UHF ASK/FSK Receiver

ATA5721
ATA5722

2. Change Notice Based on Datasheet ATA5823/ATA5824 -- UHF ASK/FSK Transceiver Rev. 4829D-RKE-06/06

Figure 1-1. Pinning QFN48

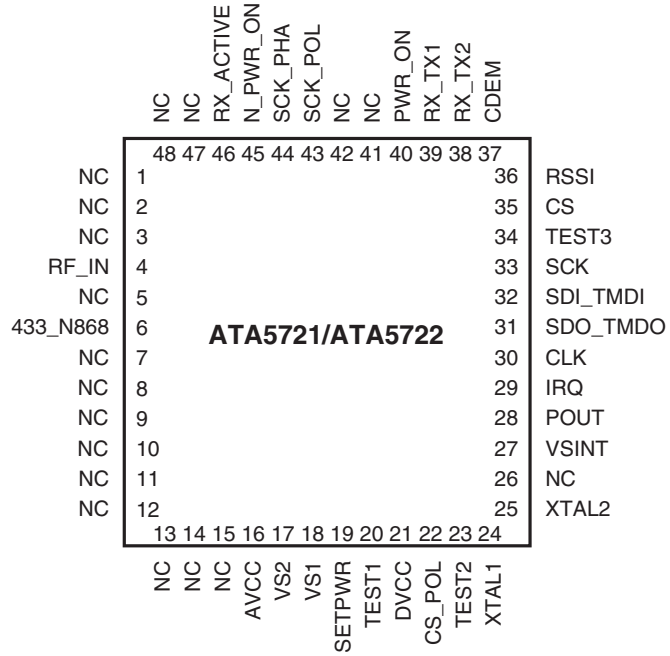
Unlike the transceiver, the receiver does not have the transmit functionality, and pins 8, 9 and 10 are not connected. The only change to the receiver is that it has a different bonding inside to disable the TX functionality.

- IC changed from transceiver to receiver due to removed TX functionality
- Device type numbers changed from ATA5823 to ATA5721 (313-MHz to 316-MHz version) and from ATA5824 into ATA5722 (433-MHz to 435-MHz version)
- No TX operation mode available due to removed bondwires of pins 8, 9 and 10
- Pins 8, 9 and 10 are NC (not connected) and have to be soldered to GND on the PCB
- No full-duplex operation mode possible
- All descriptions of TX operation in half-duplex mode are not valid
- The receiver type ATA5722 is only specified and tested in the frequency range of 433 MHz to 435 MHz, receive functionality in the 867-MHz to 870-MHz frequency band is neither specified nor tested.
- All descriptions of 867-MHz to 870-MHz applications are not valid.
